COALPAC CONSOLIDATION PROJECT ENVIRONMENTAL ASSESSMENT

RESPONSE TO SUBMISSIONS

August 2012

COALPAC PTY LTD
Castlereagh Highway
CULLEN BULLEN NSW 2790

Figure
6

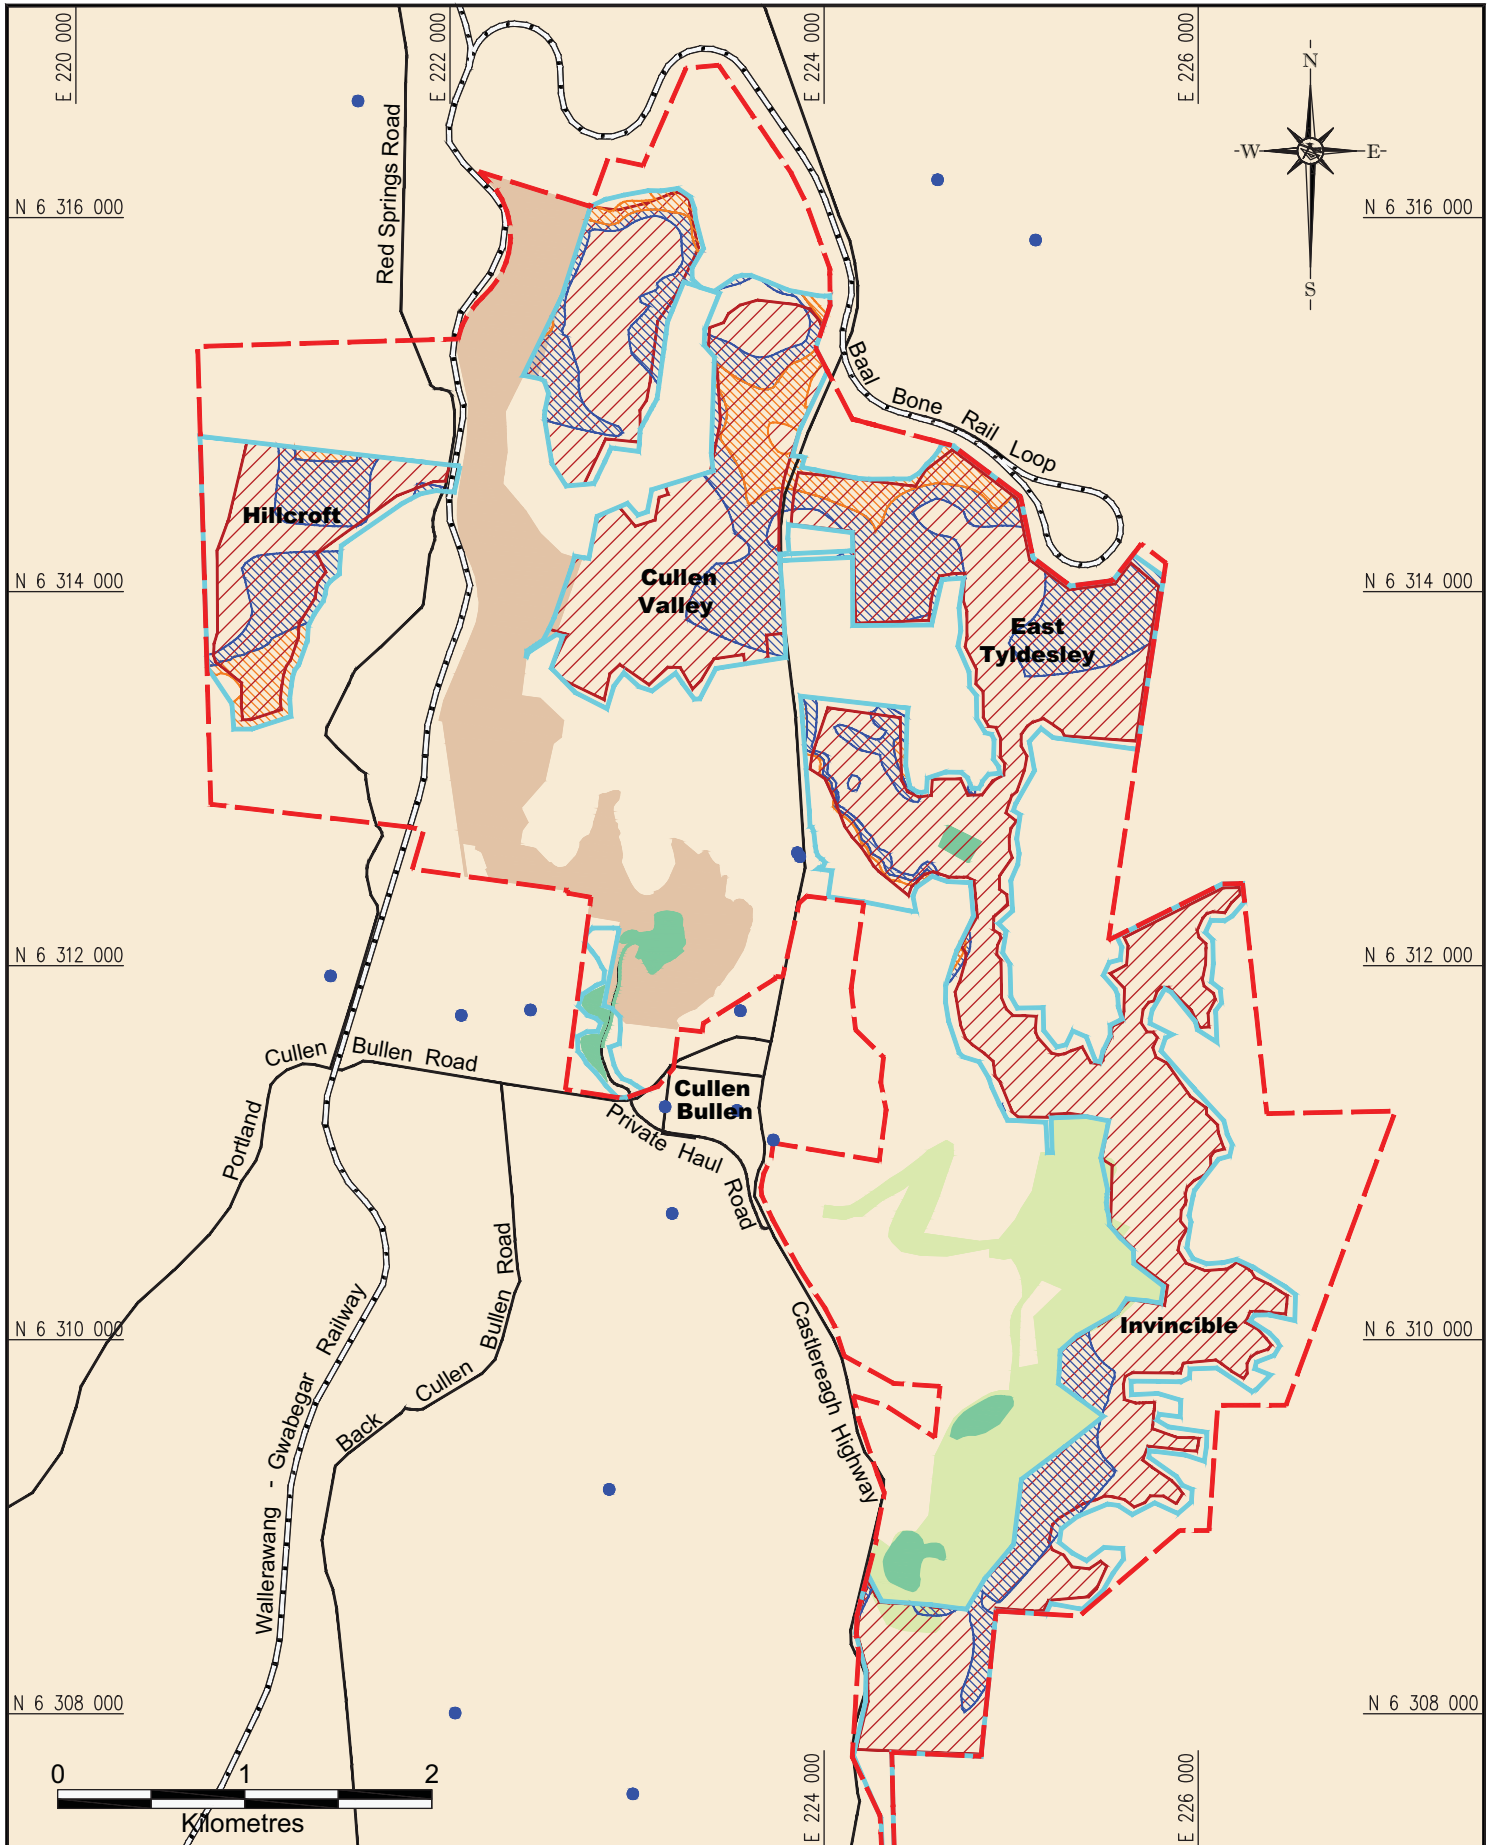
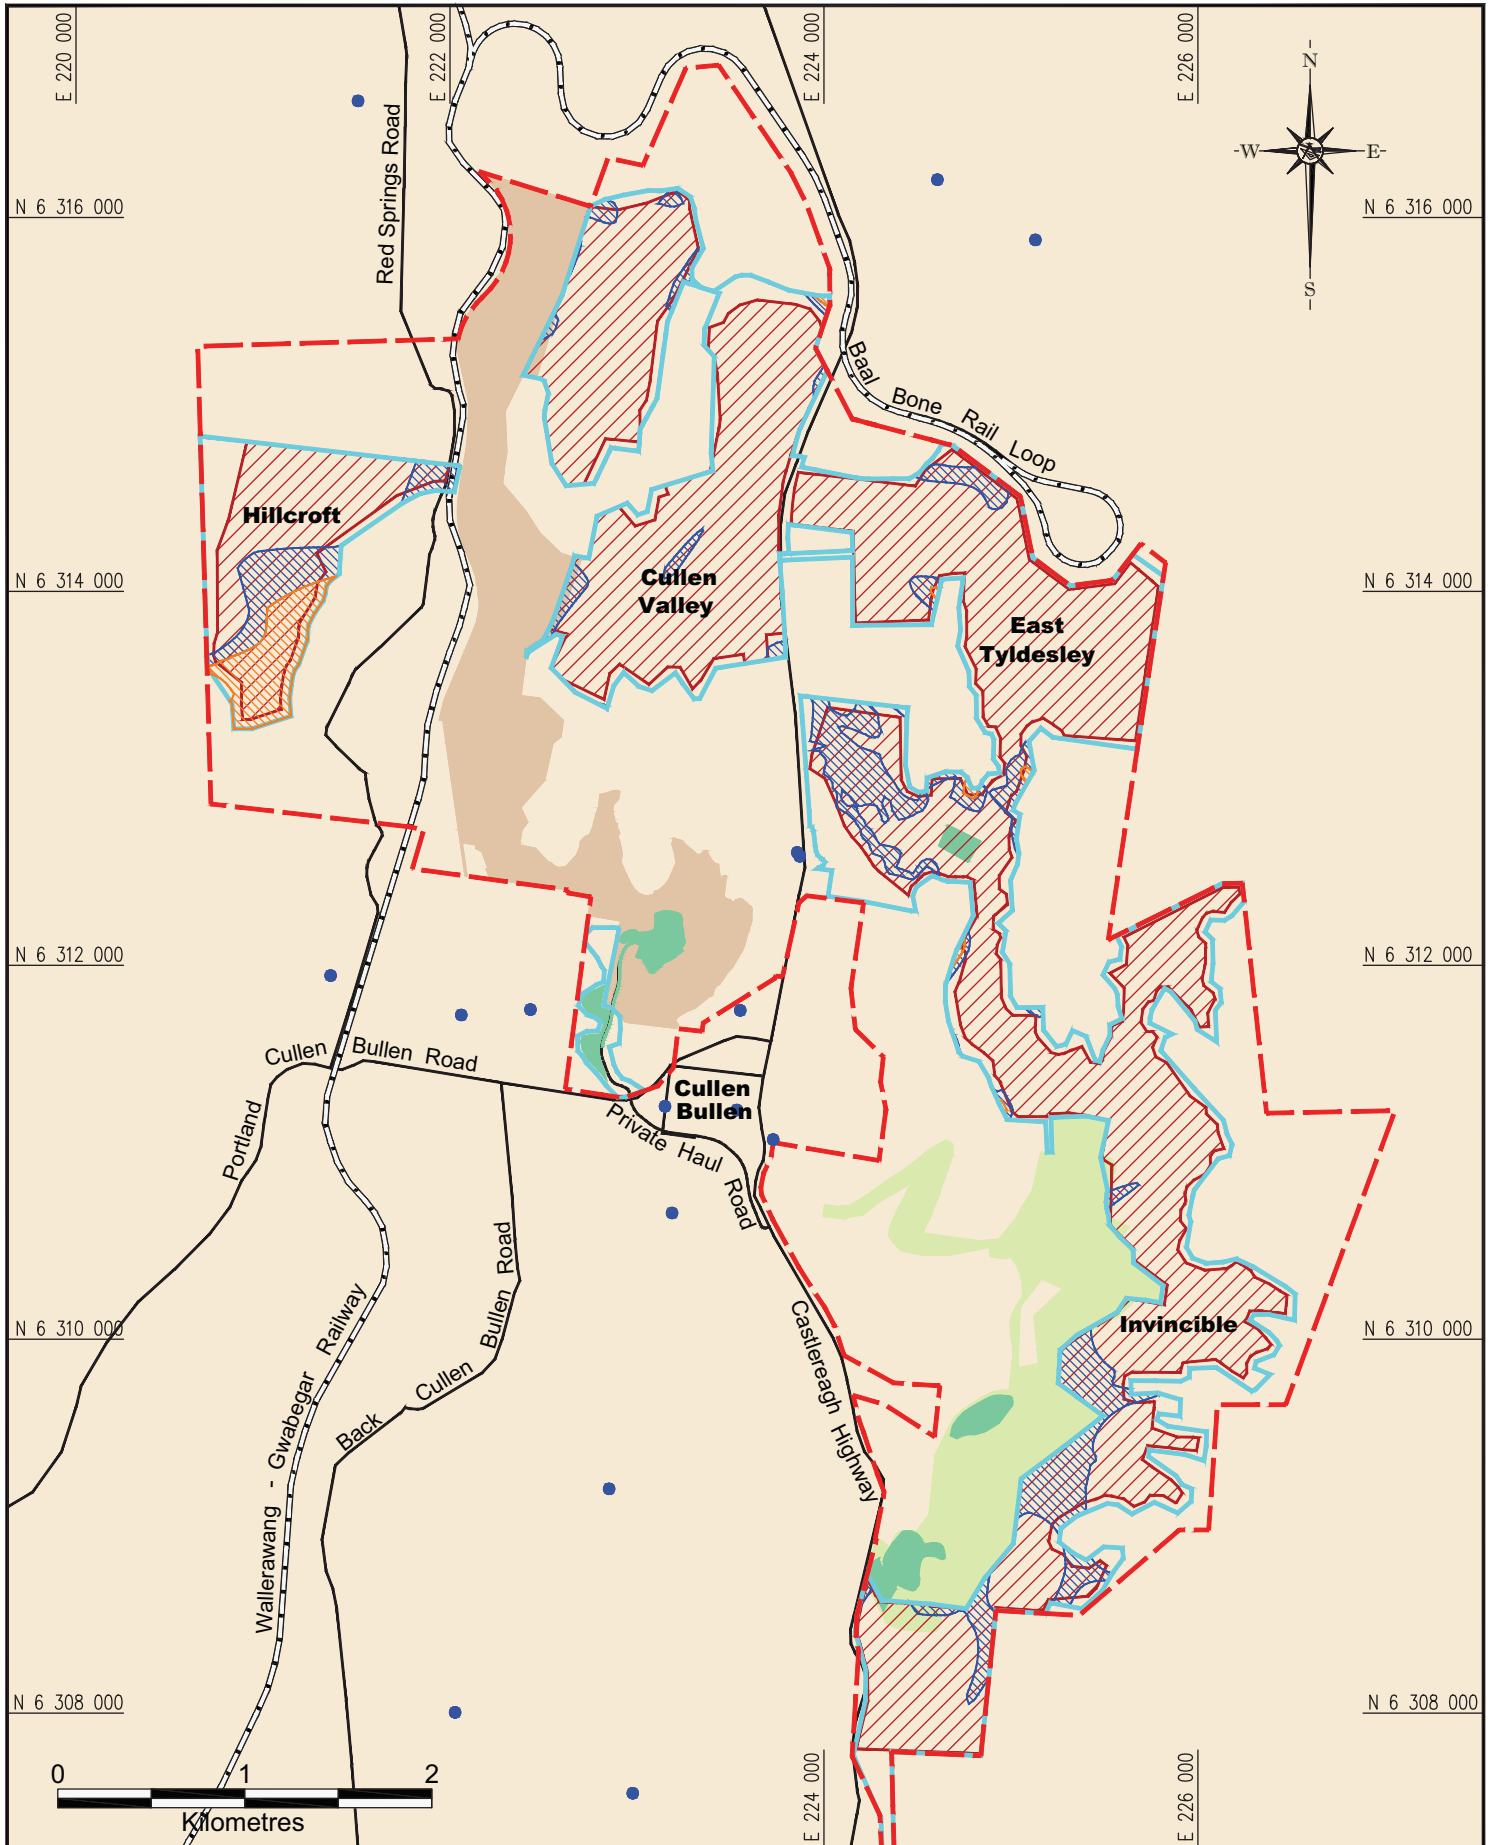
Areas within the Project Disturbance Boundary where management or modification of mining activities will be required under adverse meteorological scenarios are shown in **Figure 4** to **Figure 9**.

Figure 4 to **Figure 9** provide an outline of those areas under the five meteorological scenarios considered in the AIA where noise impacts at the nearest sensitive receptor locations are predicted to occur in the range of 35 – 40 dBA (Noise Management Zone 1) and in the range from 40 – 45 dBA (Noise Management Zone 2).

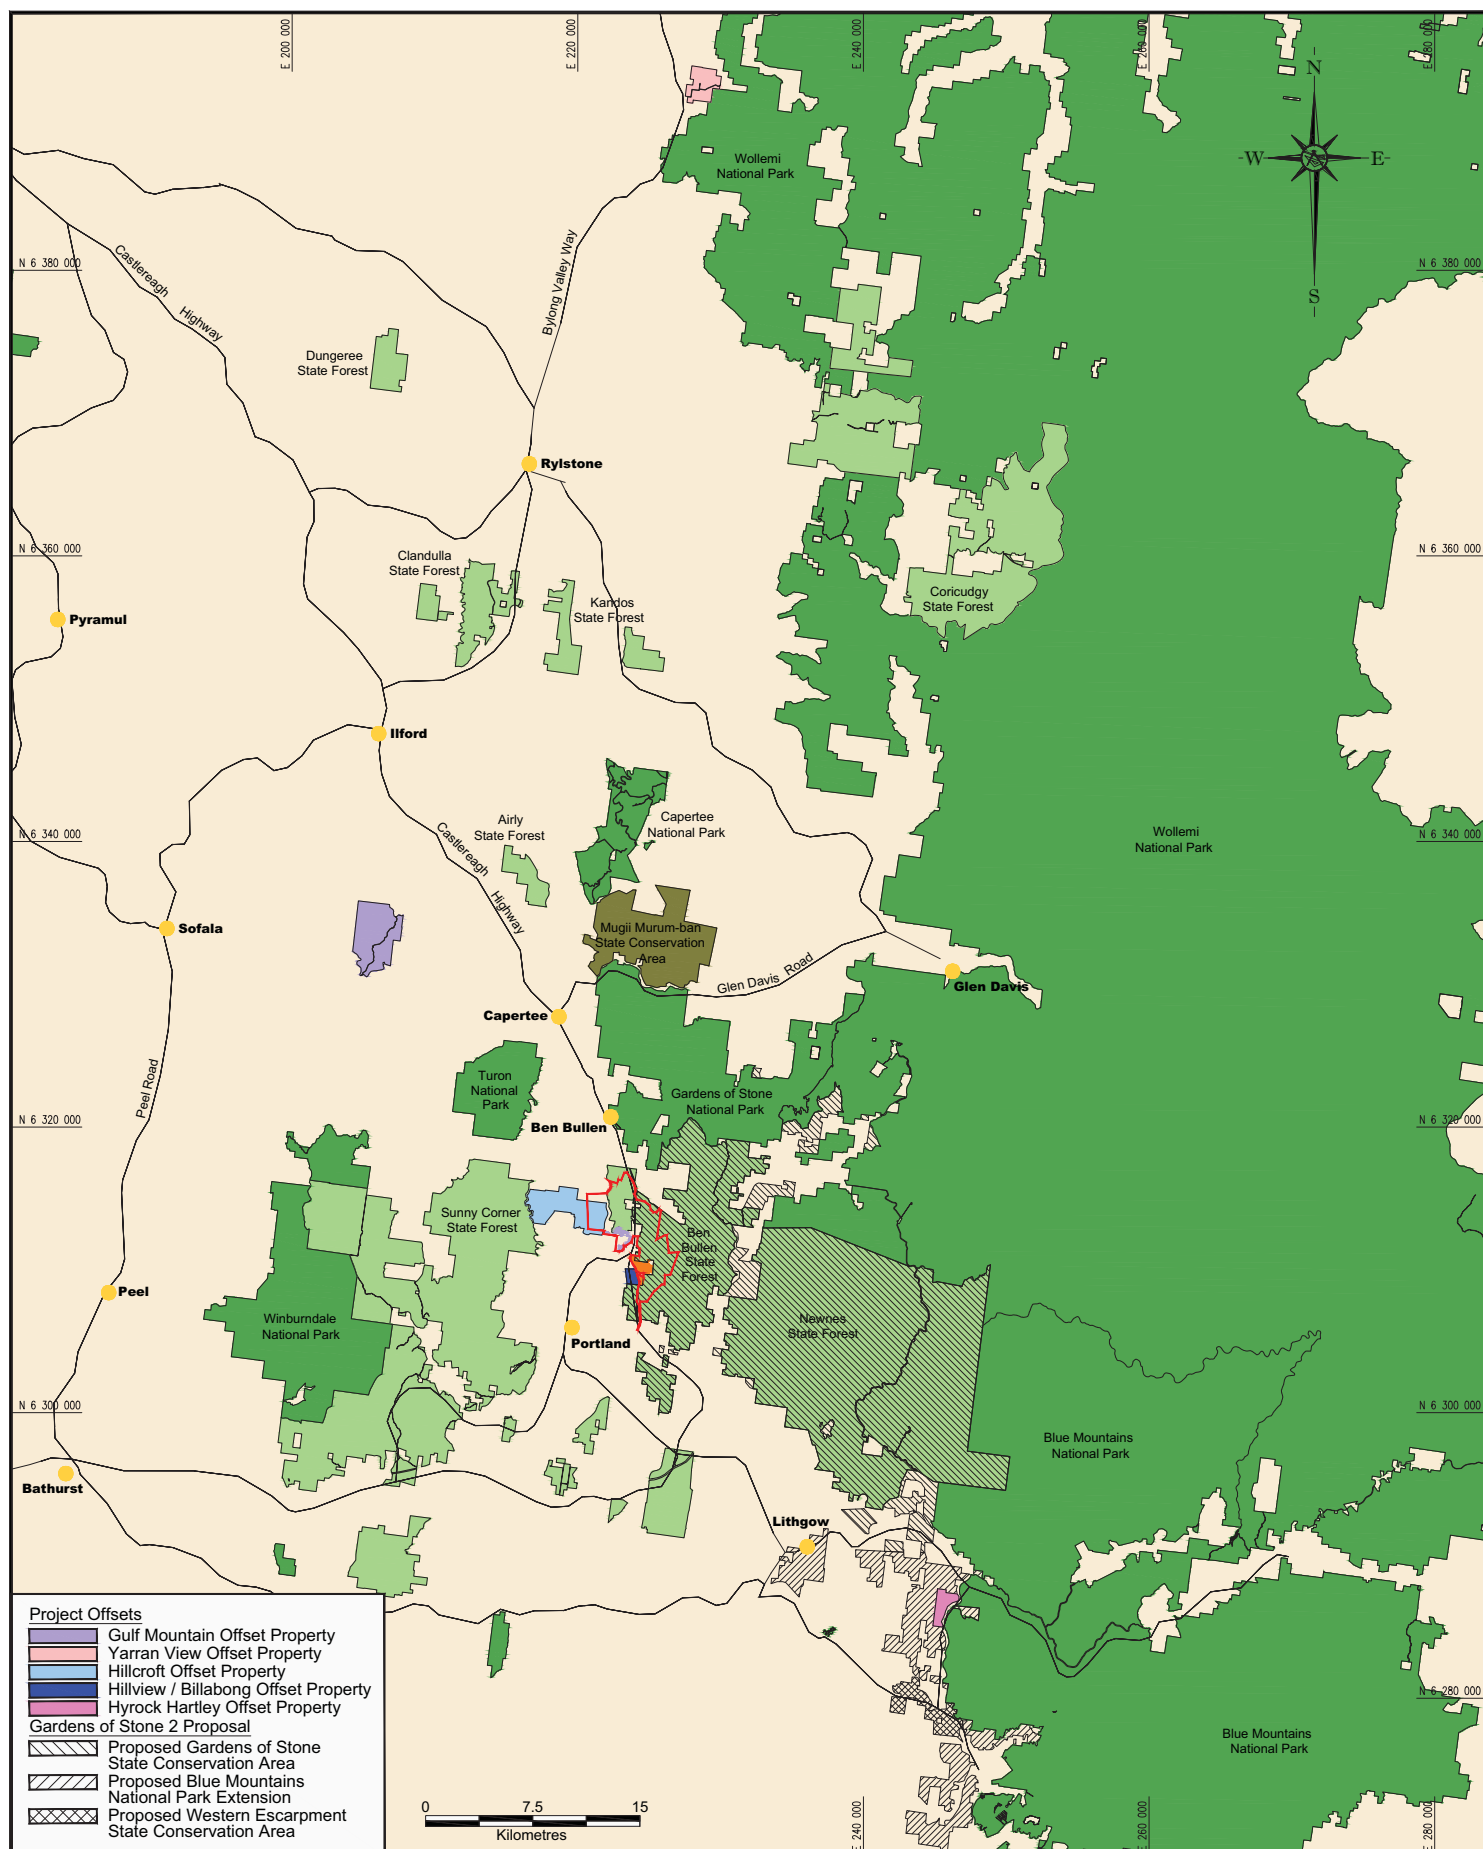
A summary of the Revised BOS including Gulf Mountain is provided in **Appendix E** and has been reproduced below in **Table 16**. The location of the Project offsets in a regional context is shown on **Figure 9**. This figure has been revised from that presented in the exhibited EA to include the Gulf Mountain property.
